ADDENDUM NO.: THREE

DATE OF ADDENDUM: January 12, 2016

**NEW MANUFACTURING TECHNOLOGY CENTER
ASNUNTUCK COMMUNITY COLLEGE
170 ELM STREET
ENFIELD, CT
BI-CTC-488**

SKETCH TITLE WALL SECTION THRU EXISTING ENTRY

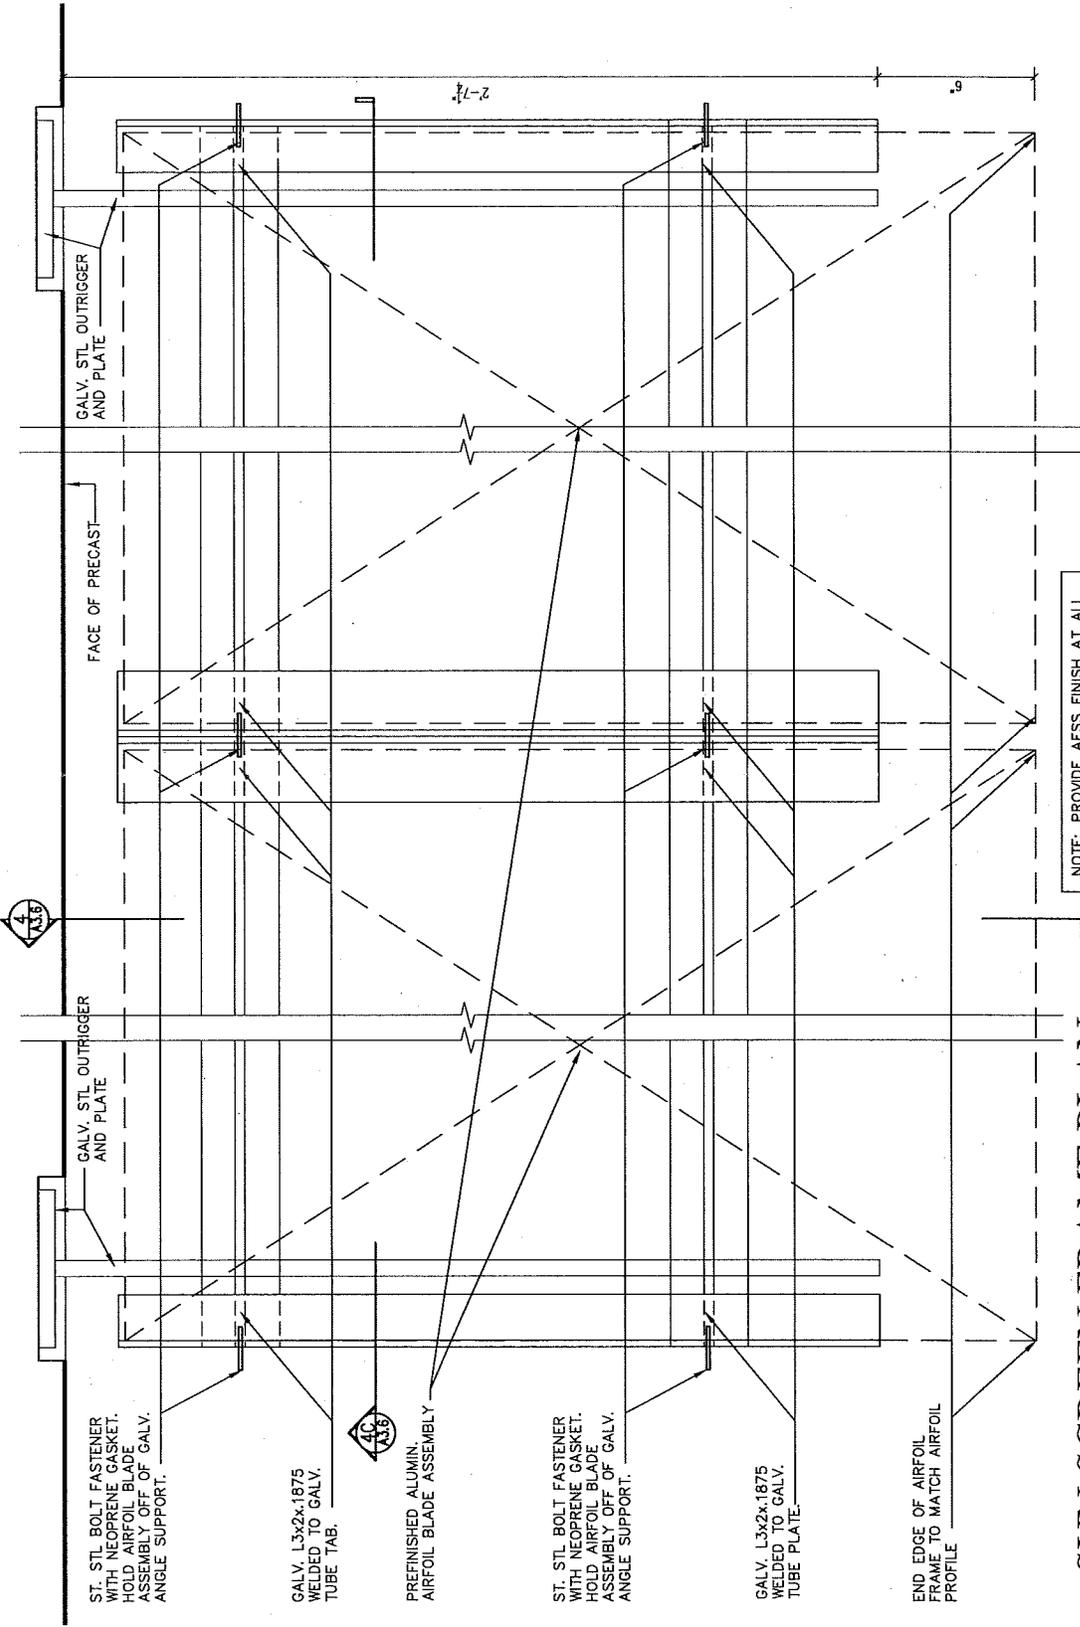
1. **DELETE** Section 13/A3.3 and **REPLACE** with new Section 13/A3.3 as shown by attached sketch AD3-SK-A3.3.1 dated 1/11/2016.
2. **DELETE** Section 13A/A3.3 and **REPLACE** with new Section 13A/A3.3 as shown by attached sketch AD3-SK-A3.3.2 dated 1/11/2016.

AD3-SK1-ES1
SKETCH NO.
SCALE: 1/8" = 1'-0"
COPYRIGHT ©
DATE: 1/11/2016

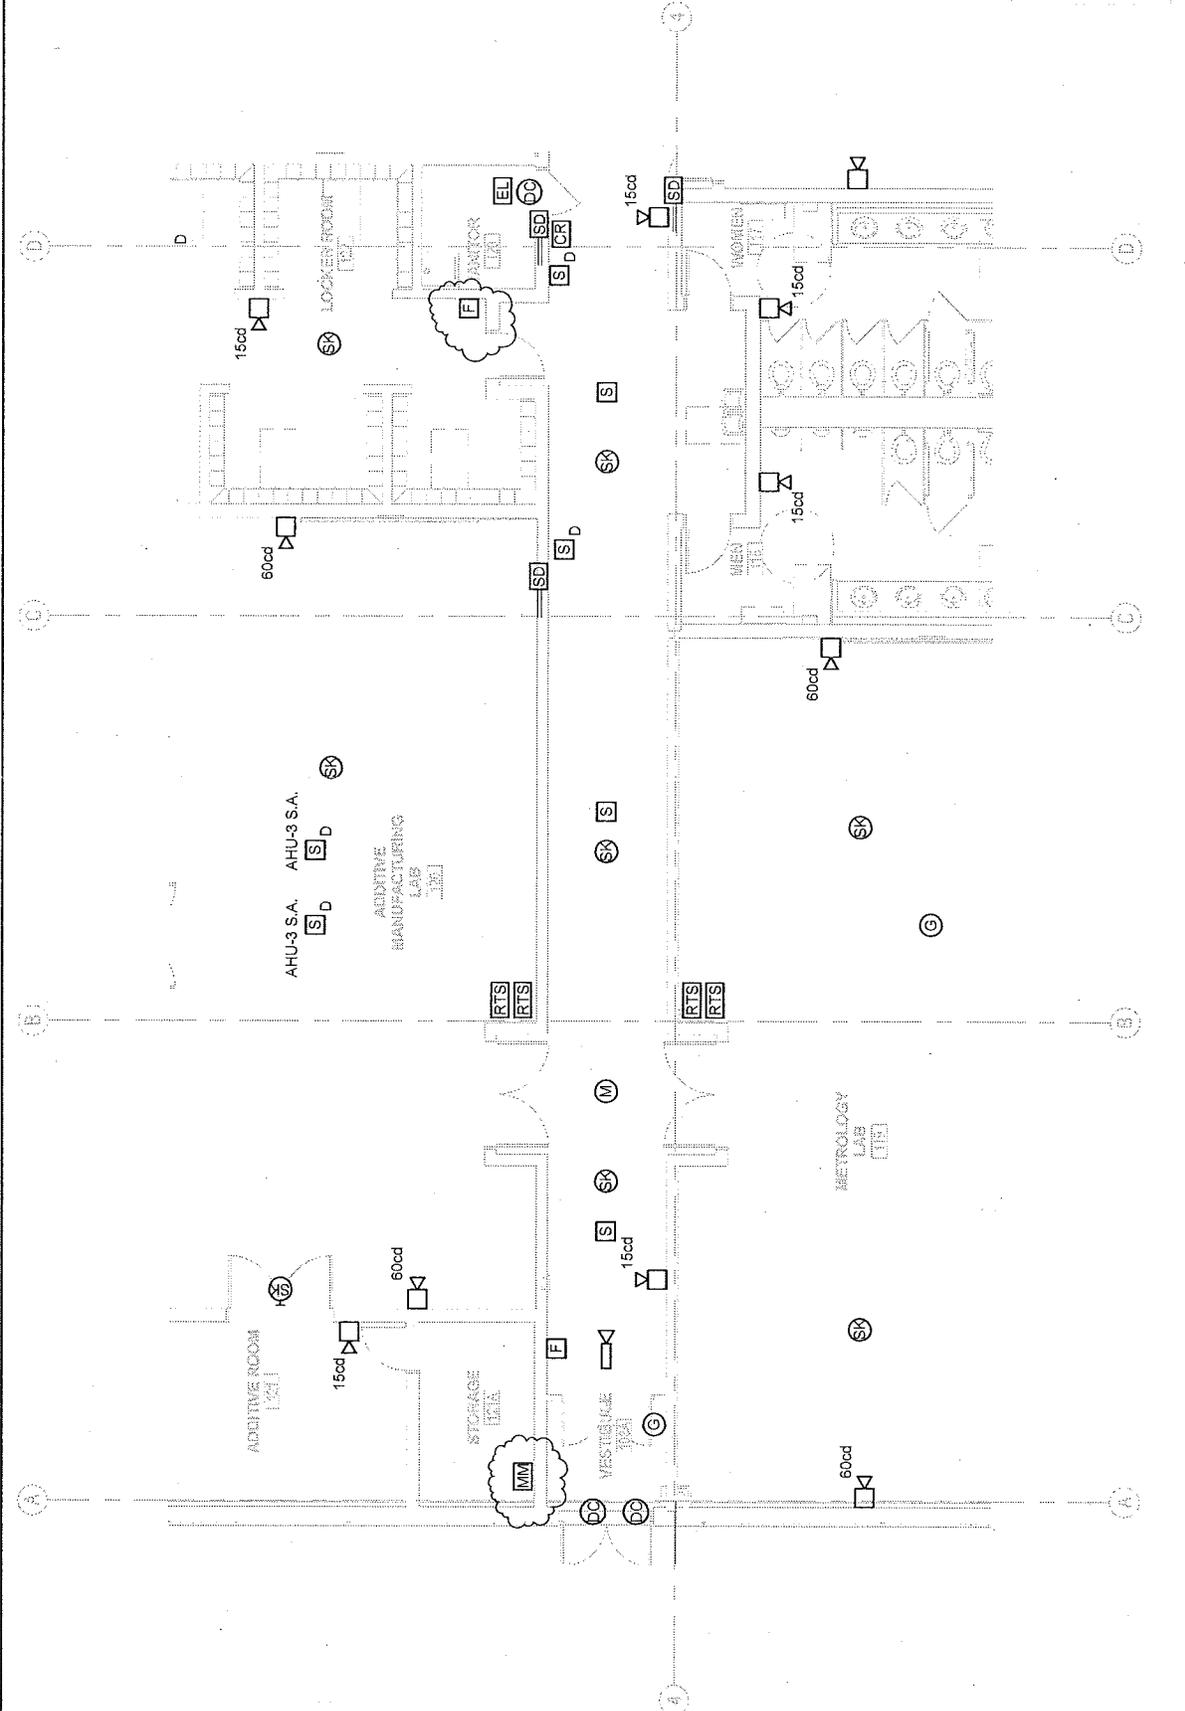
DRAWING ES1.1 – Refer to Addendum #3 sketch AD3-SK1-ES1.1 for fire alarm REVISIONS.

SKETCH NO.
AD3-SK1-SE.1

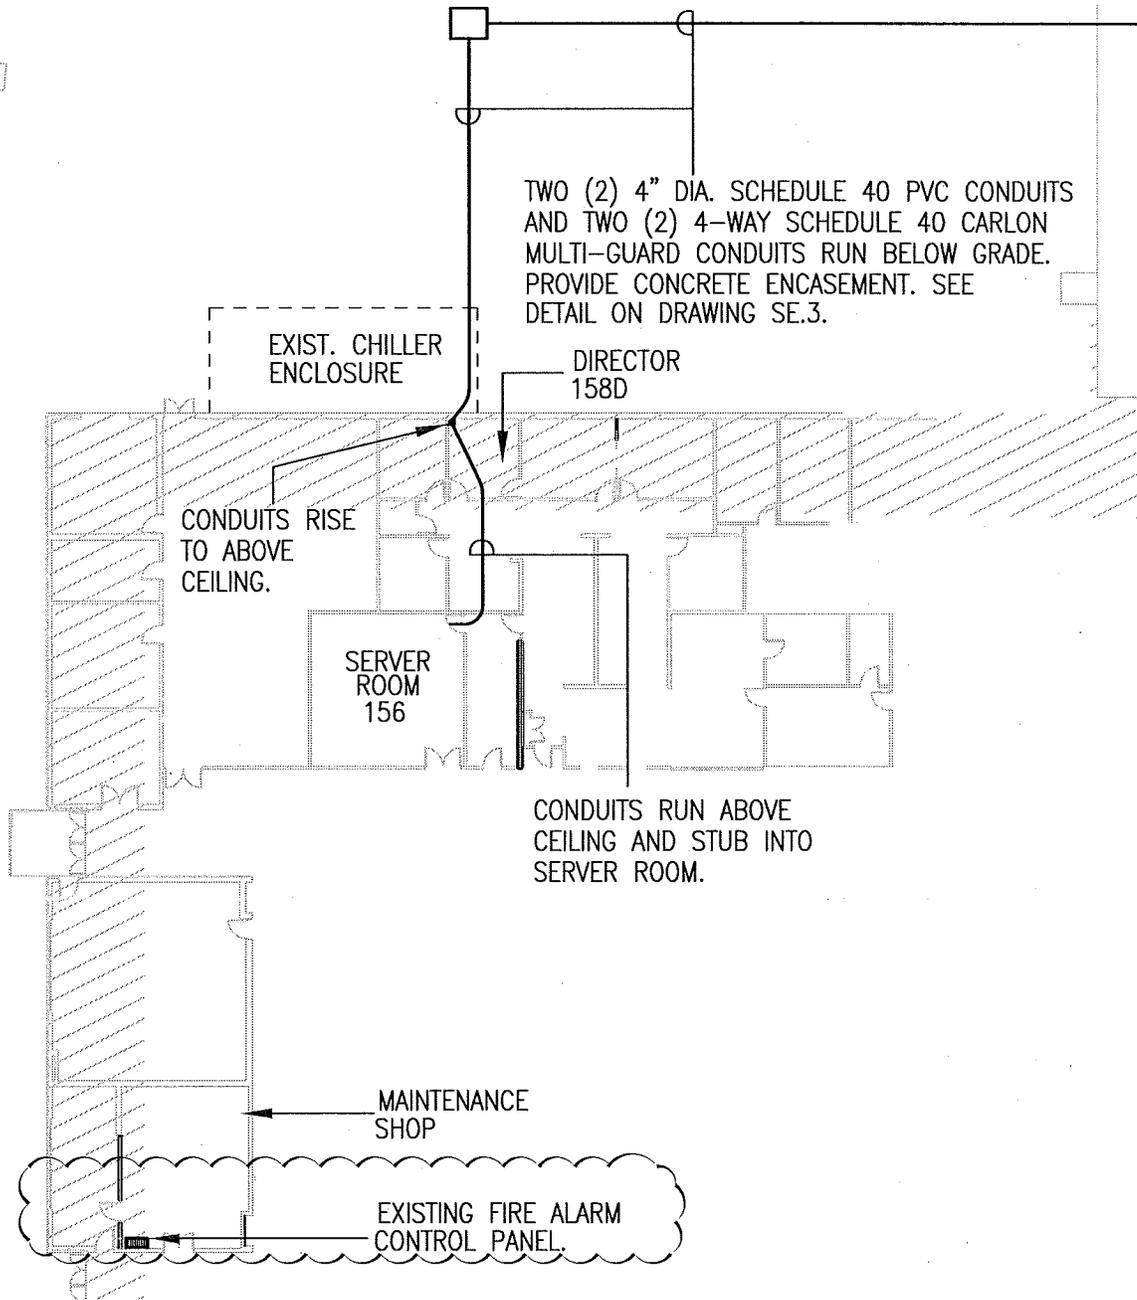
DRAWING SE.1 – Refer to Addendum #3 sketch AD3-SK1-SE1.1 for CHANGE to wiring serving existing site lighting standard.

AD3-SK2-M1.1
 SKETCH NO.
 SCALE: 1/8" = 1'-0"
 DATE 1/11/2016
 COPYRIGHT ©
 170 Elm Street, Enfield, Connecticut
 BEHNS ASSOCIATES, LLC
 ARCHITECTURAL ENGINEERS

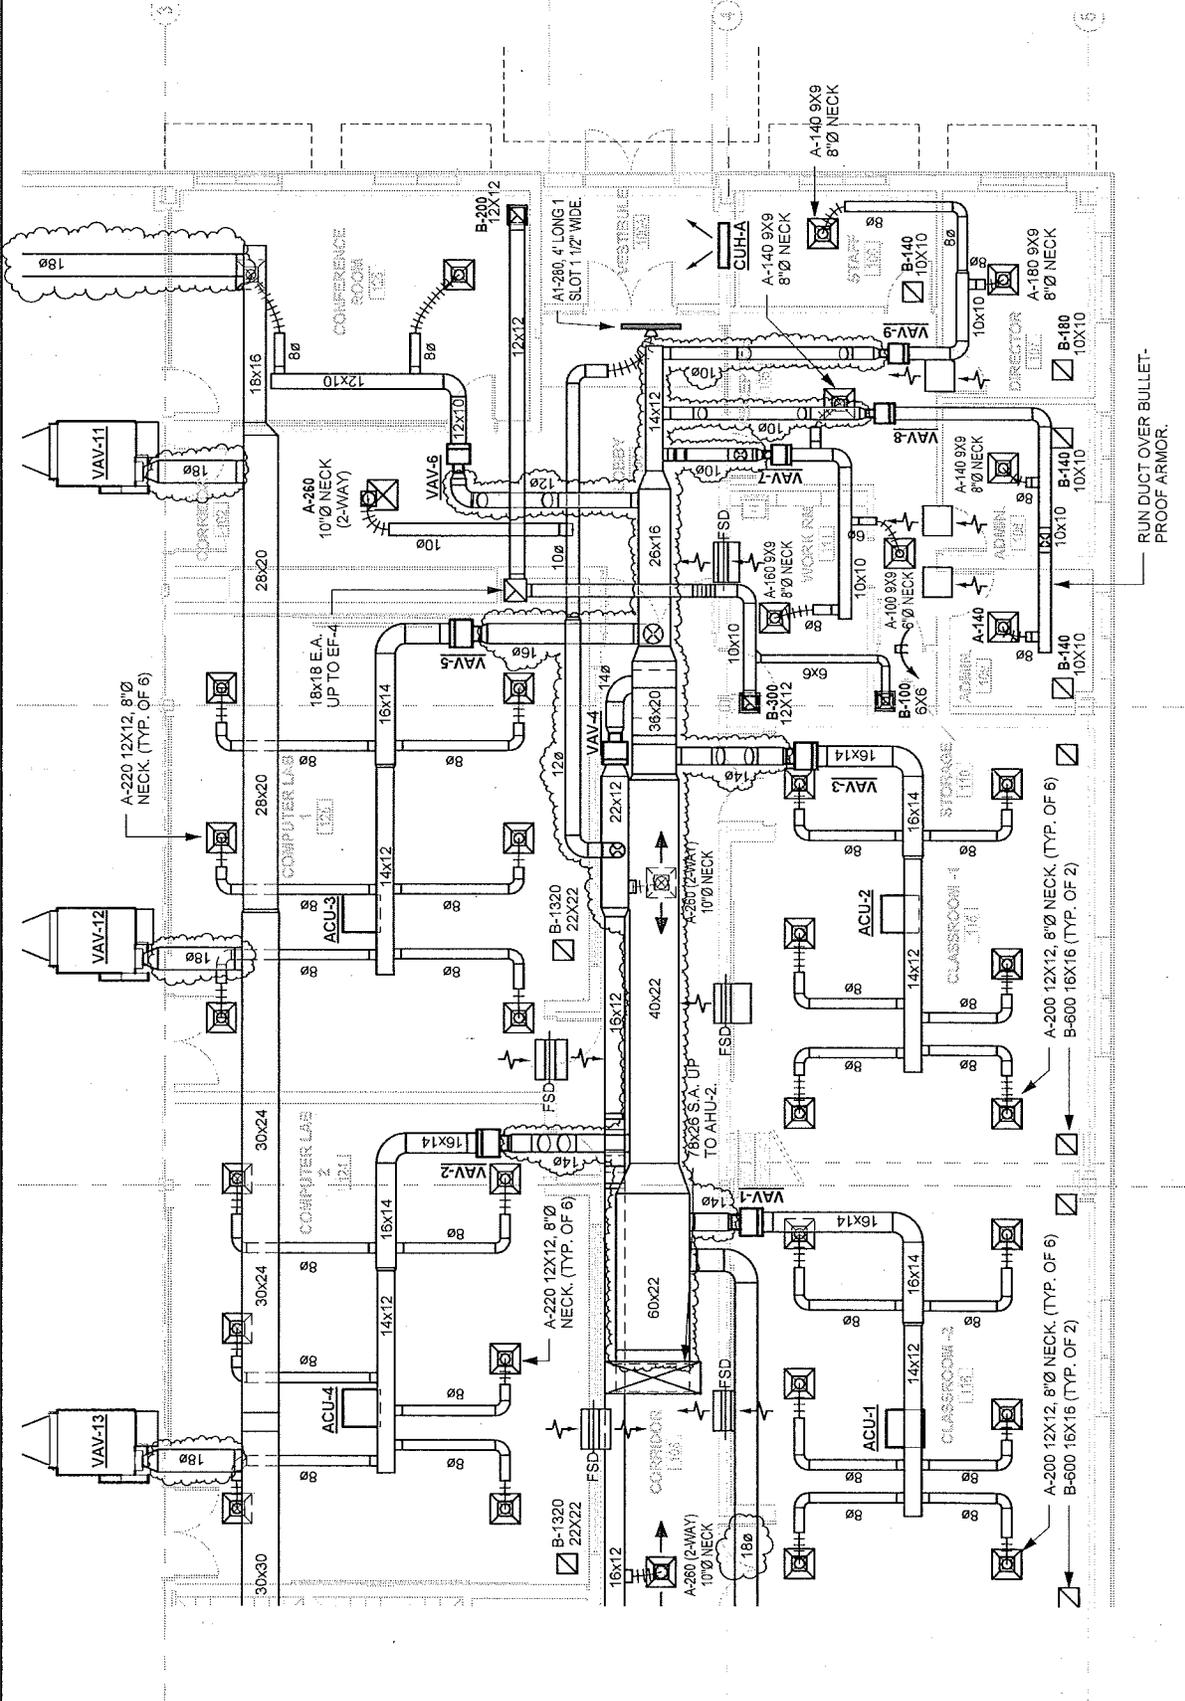
DRAWING M1.1 – FIRST FLOOR HVAC PLAN: CHANGE: Duct sizes; refer to AD-3-SK1-M1-1 and AD3-SK2-M1-1.

RUN DUCT OVER BULLET-
 PROOF ARMOR.

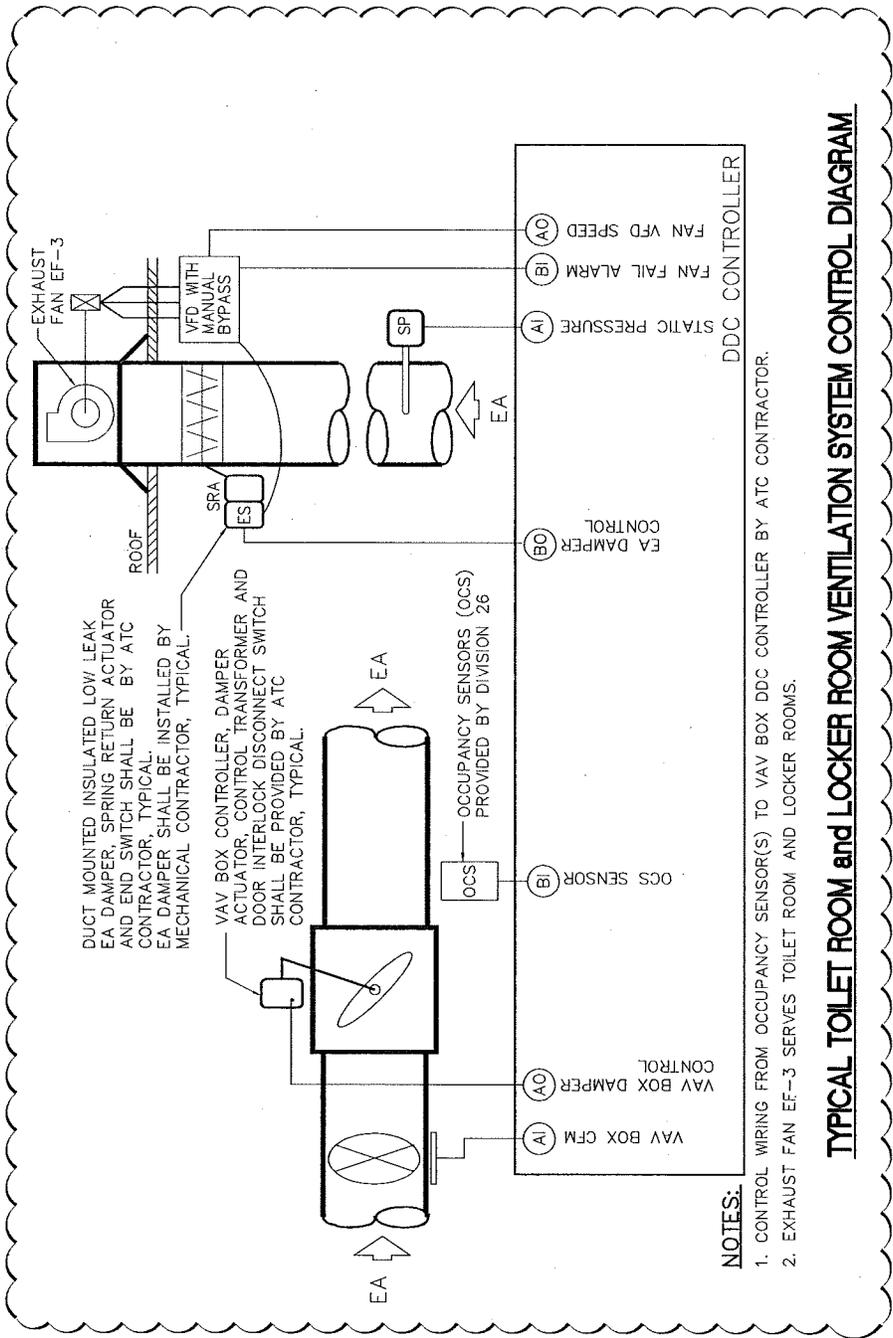
DRAWING M1.2– FIRST FLOOR HYDRONIC PIPING PLAN – ADD: By-pass at the end of the hydronic loop. Refer to AD3-SK1- M1.2.

1 1/2" BY PASS
WITH CIRCUIT SETTER
AND BALL VALVE

SPLIT SYSTEMS CONTROLS DIAGRAM

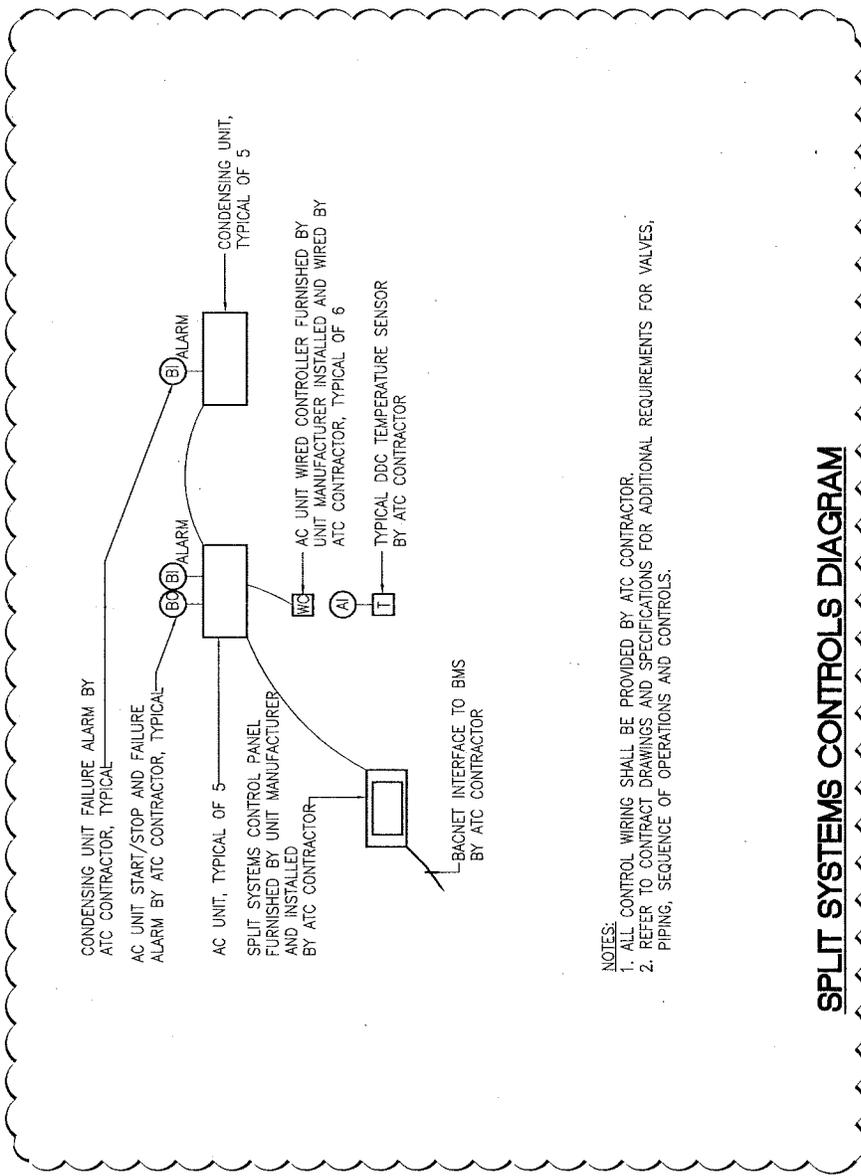
DRAWING M5.2 – TEMPERATURE CONTROLS – ADD; controls for ductless split systems. Refer to AD-3-SK2-M-5.2.

- NOTES:
1. ALL CONTROL WIRING SHALL BE PROVIDED BY ATC CONTRACTOR.
 2. REFER TO CONTRACT DRAWINGS AND SPECIFICATIONS FOR ADDITIONAL REQUIREMENTS FOR VALVES, PIPING, SEQUENCE OF OPERATIONS AND CONTROLS.

AD3-SK3-EP1.1
 SKETCH NO.
 SCALE: 1/8" = 1'-0"
 DATE: 1/11/2016
 COPYRIGHT ©

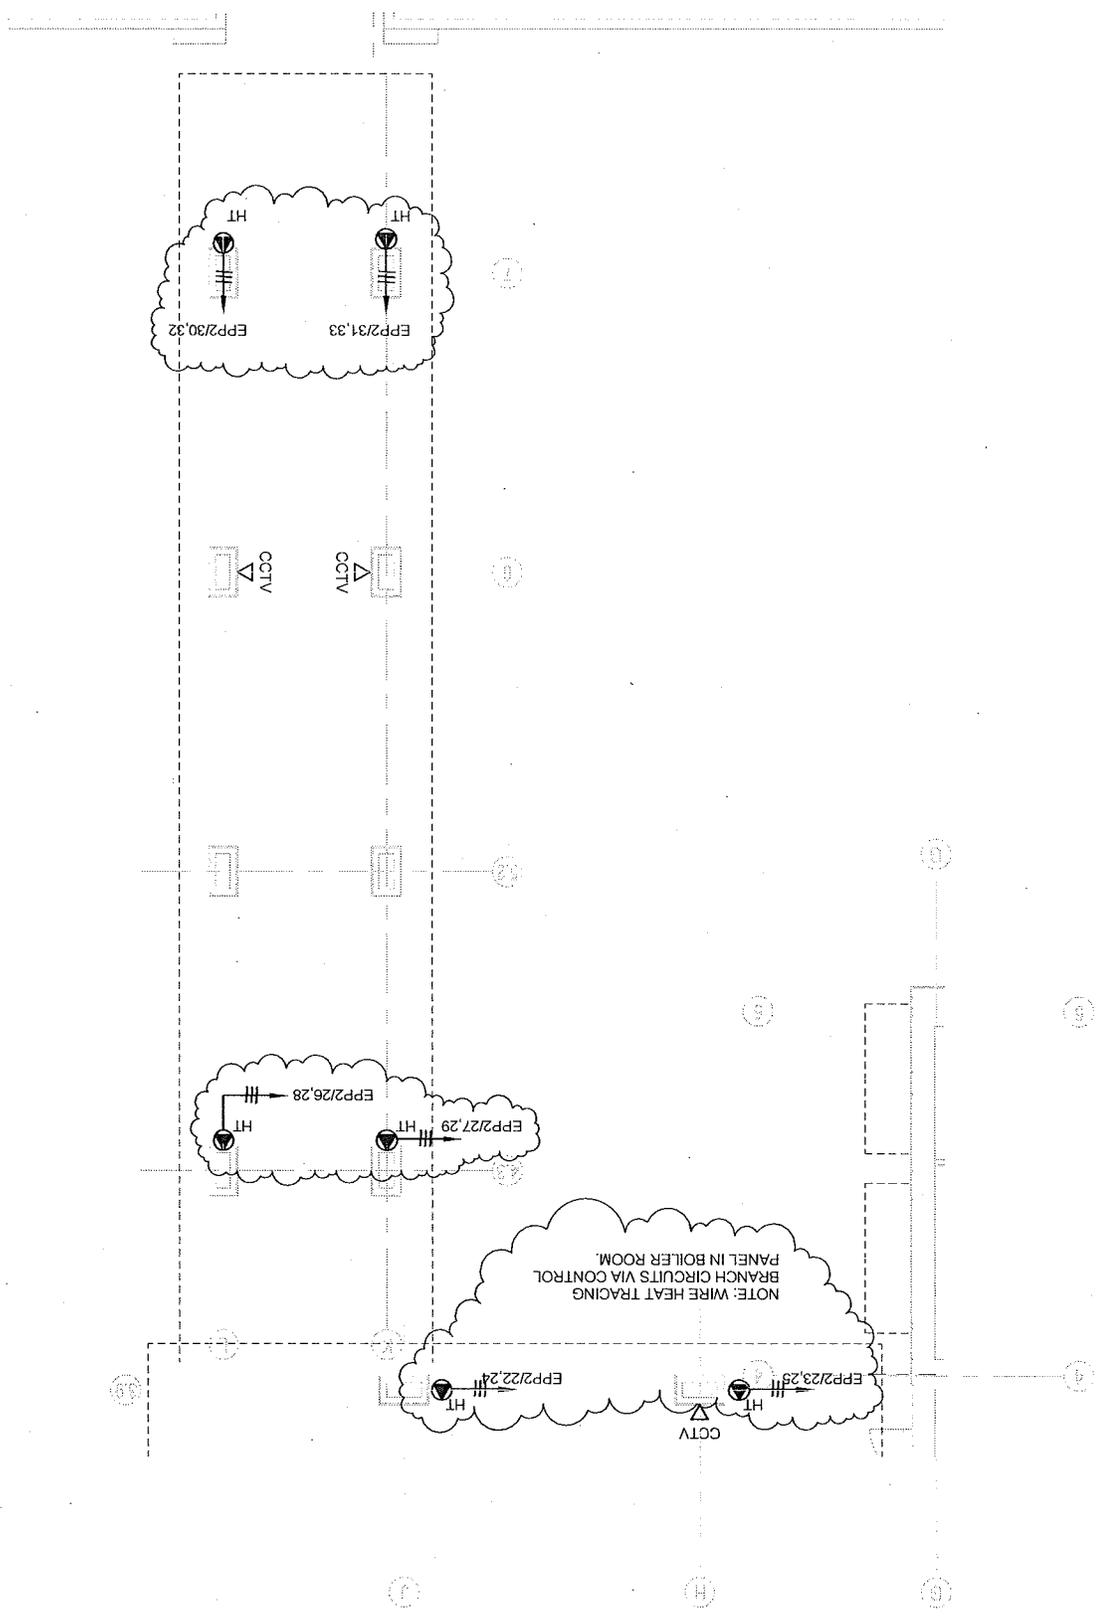
DRAWING EP1.1 – Refer to Addendum #3 sketch AD3-SK3-EP1.1 for CHANGES to heat tracing branch circuits.
